**Town of Kittery  
 Planning Board Meeting  
 January 12, 2023**

**ITEM 3 – 41 Route 236 – Preliminary Site Plan Review**

**RE: Preliminary Site Plan Review – Request for Continuance  
Well Field 44 Cannabis Dispensary (Tax Map 29, Lot 1)  
41 Route 236, Kittery, Maine**

DRAWN BY: MJS  
REVISION DATE: E : 12/29/22  
SHEET: 1

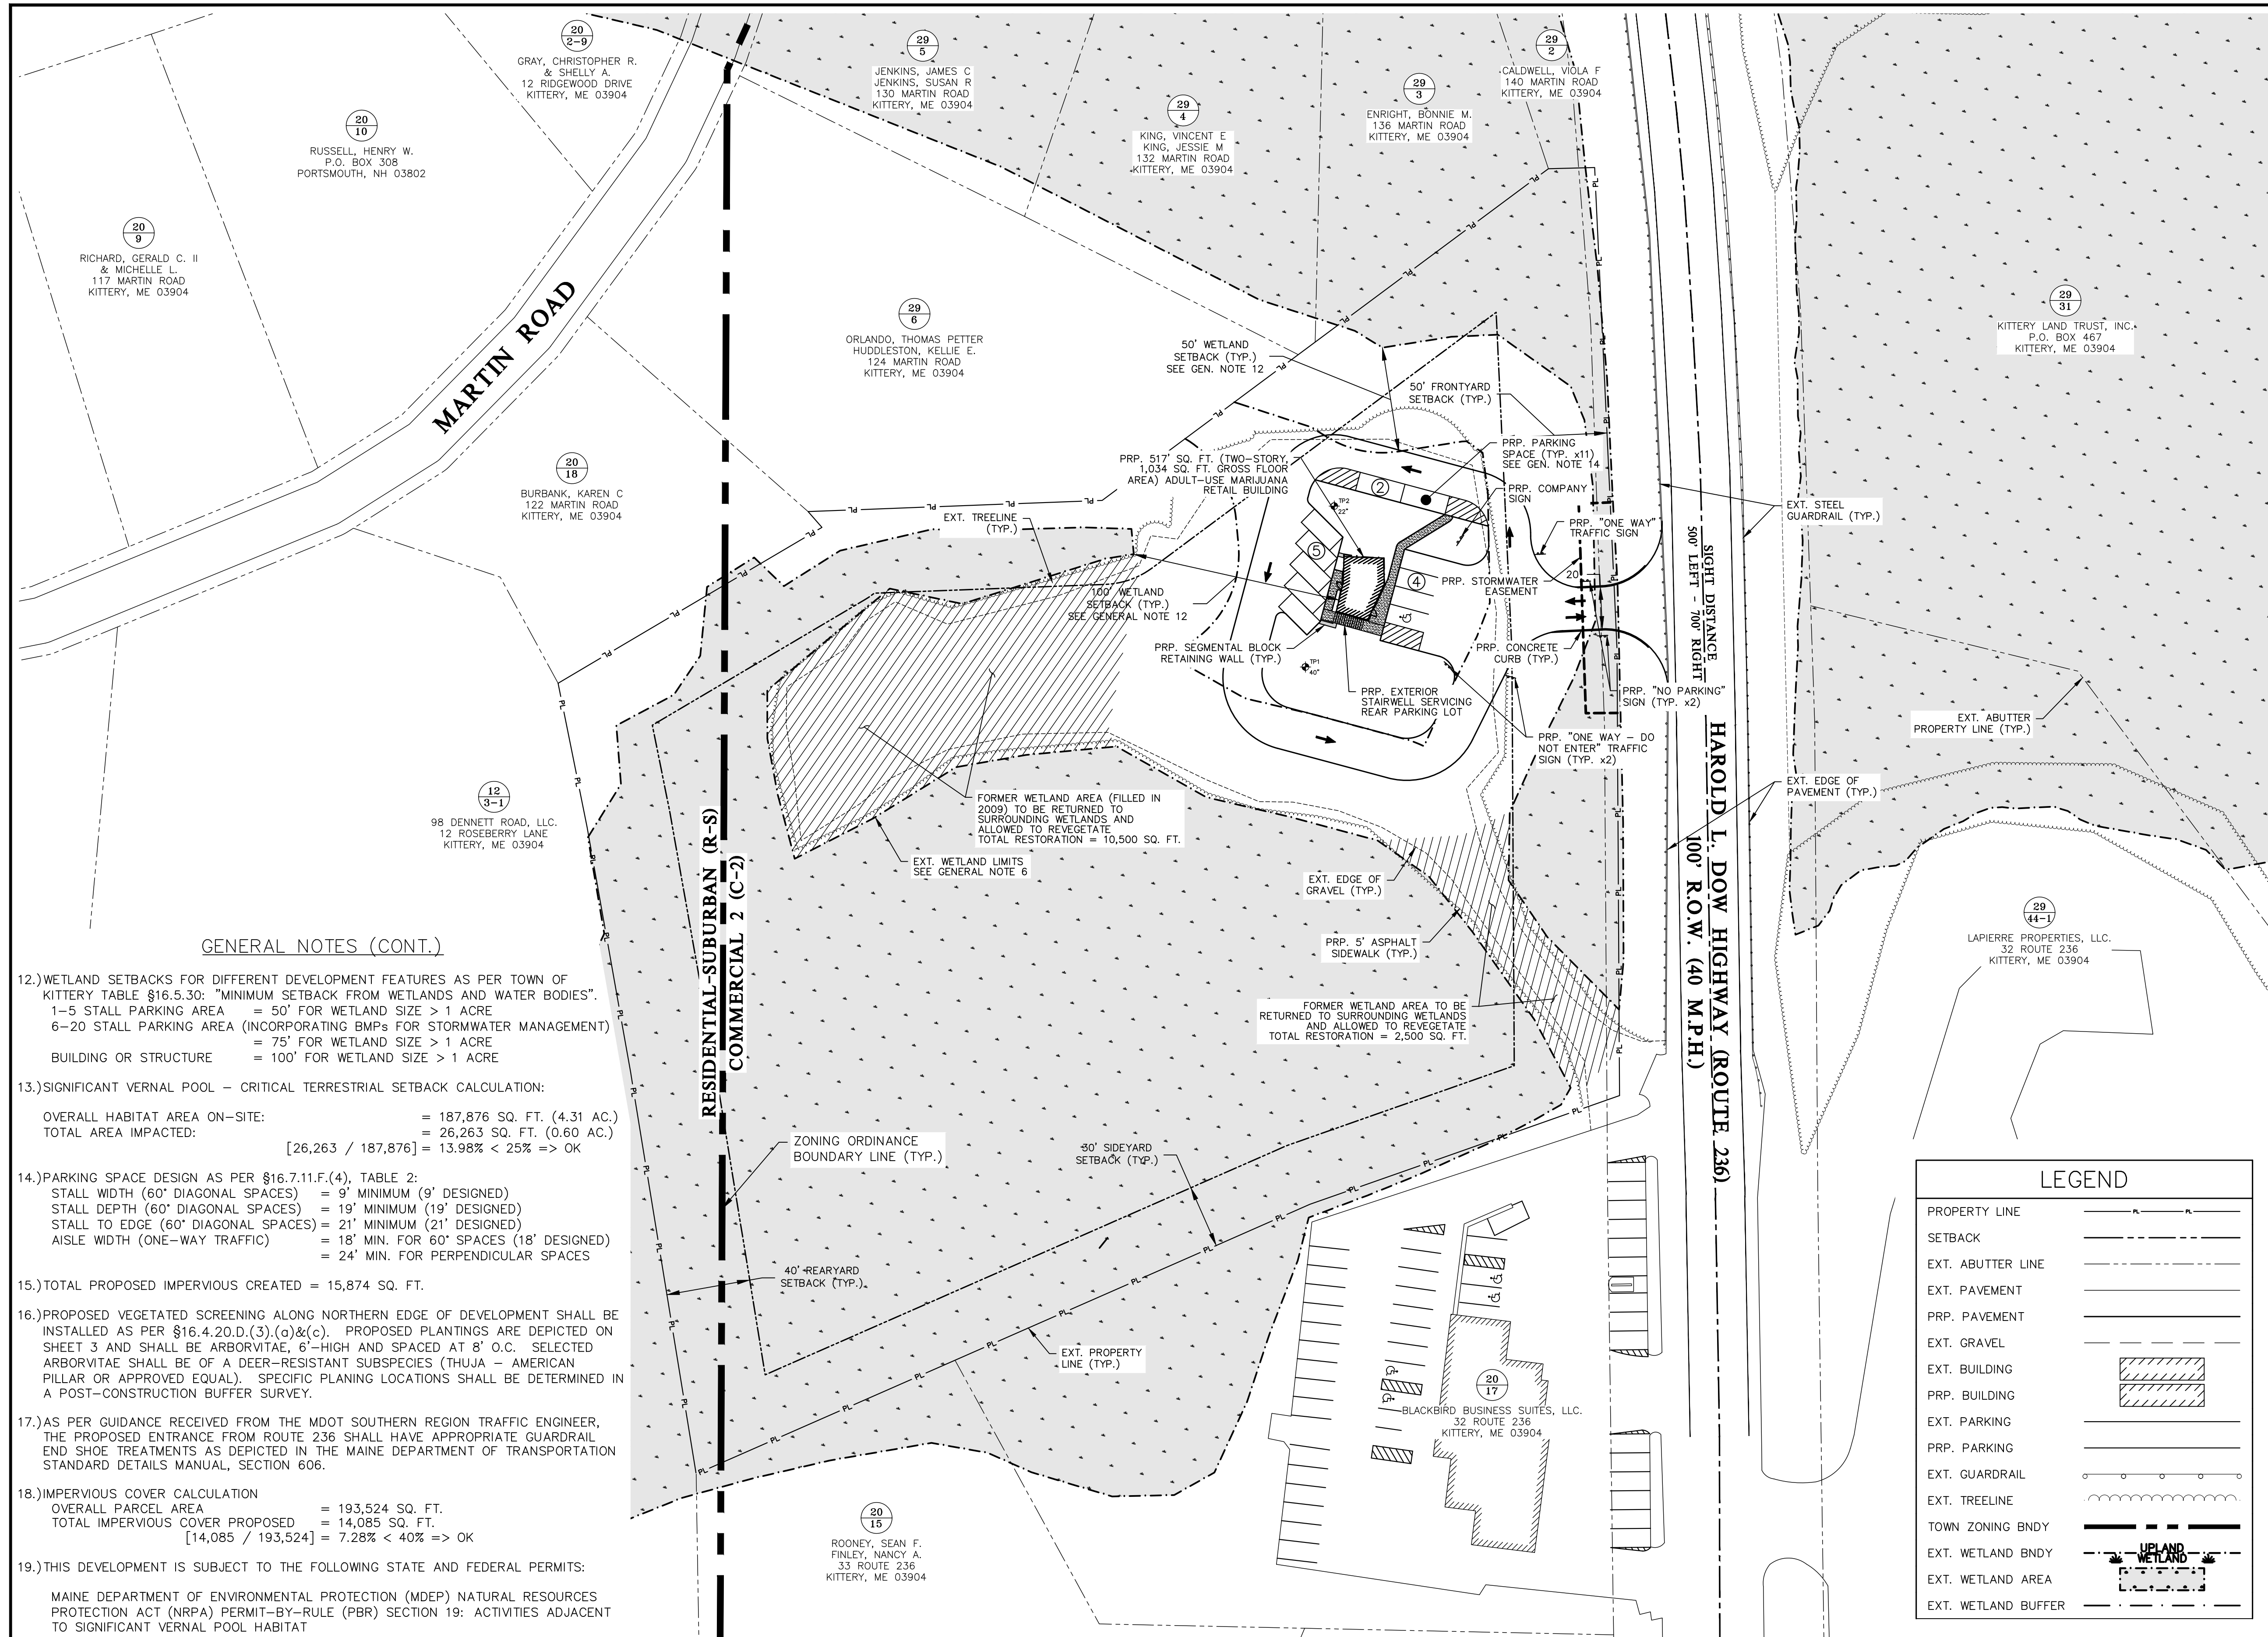
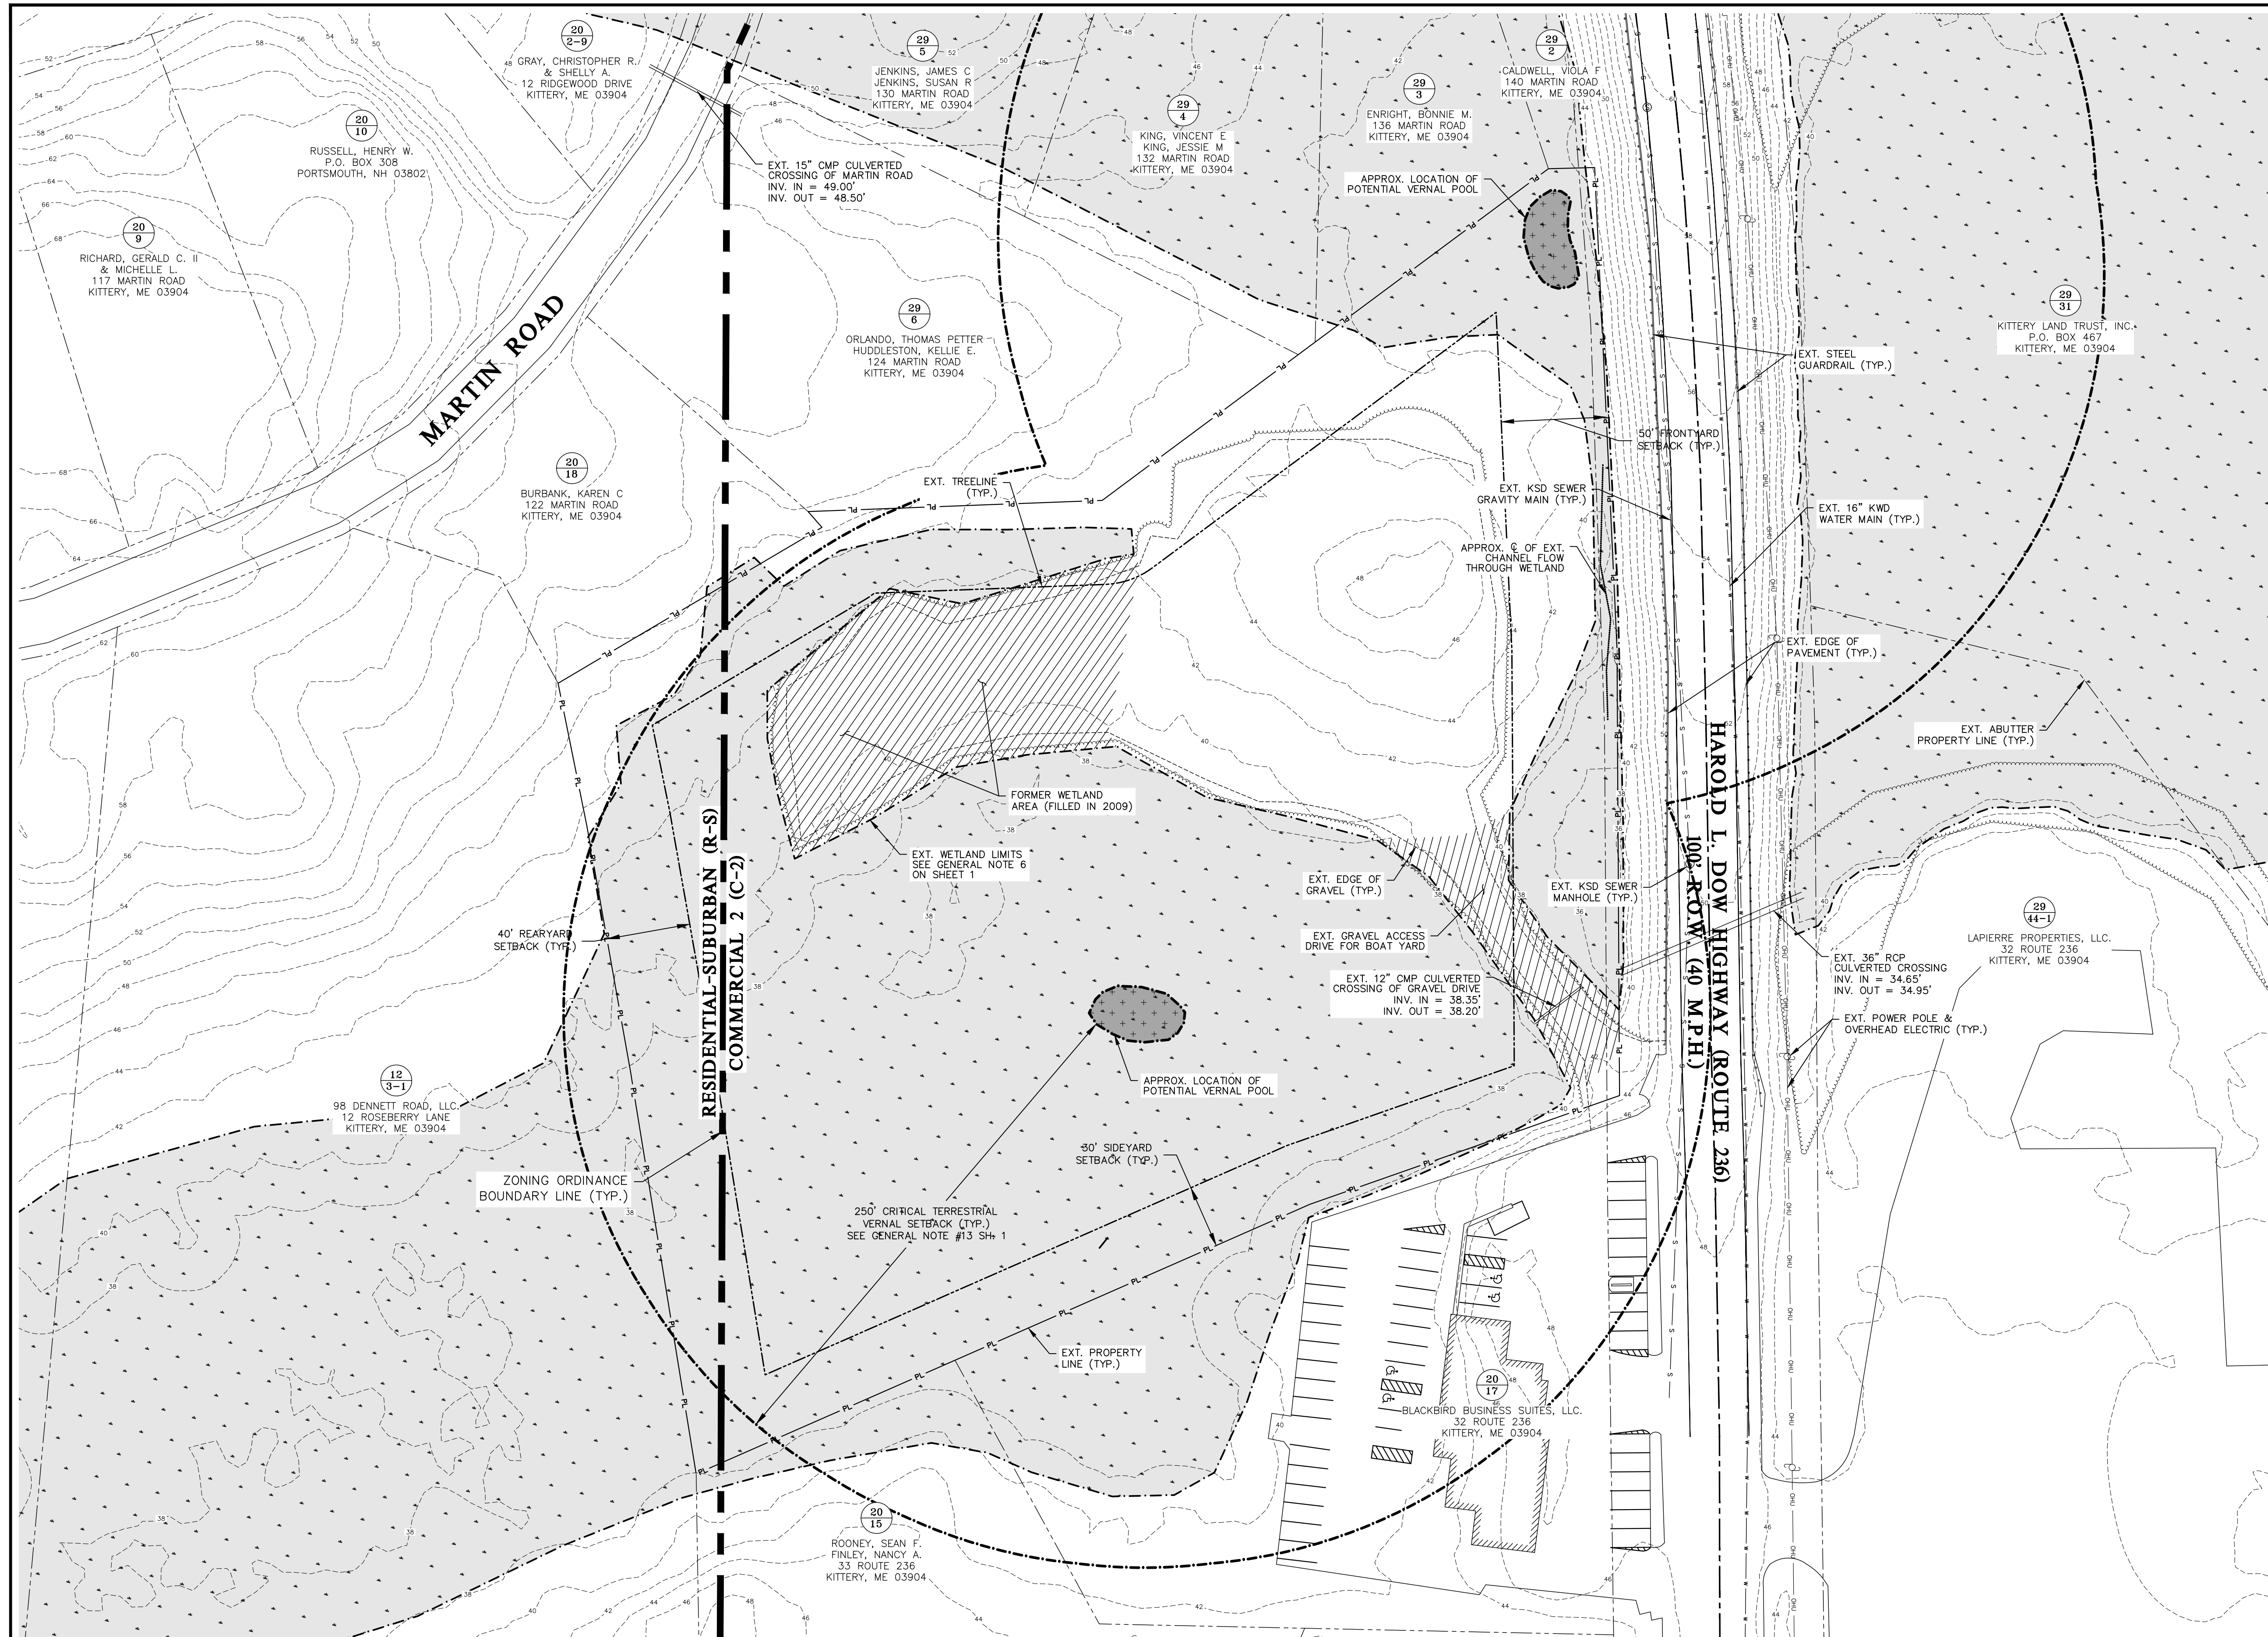
- §16.4 Zoning Regulations
  - General Note #3 on Sheet 1 (Preliminary Site Plan) has been updated to provide proposed street frontage and building height to demonstrate compliance with the dimensional standards of the C-2 zoning district.

- General Note #18 on Sheet 1 has been added to provide an impervious cover calculation as requested.
  - An updated Architectural Elevation of the proposed building is attached as requested.

- §16.5 General Development Requirements
  - General Note #19 on Sheet 1 has been added to include all relevant State and Federal Permits that apply to this project and that have been applied for.

- General Note #14 on Sheet 1 has been added to demonstrate the proposed development's compliance with the parking and loading requirements of Kittery Town Code §16.7.11.F.(4), Table 2.

- General Notes #6 & #7 on Sheet 1 have been updated to correctly list the title of the project wetland scientist and project soil scientist, respectively.

- General Note #10 on Sheet 1 has been updated to callout the appropriate entities that shall be supplying water and sewer connections to the proposed development.

- The proposed hydrant referenced in General Note #11 on Sheet 1 has been displayed on Sheet 3 as intended.
  - All relevant Plan Set sheets have been updated to display the approximate location of vegetative screening plantings along the northern edge of development as requested.
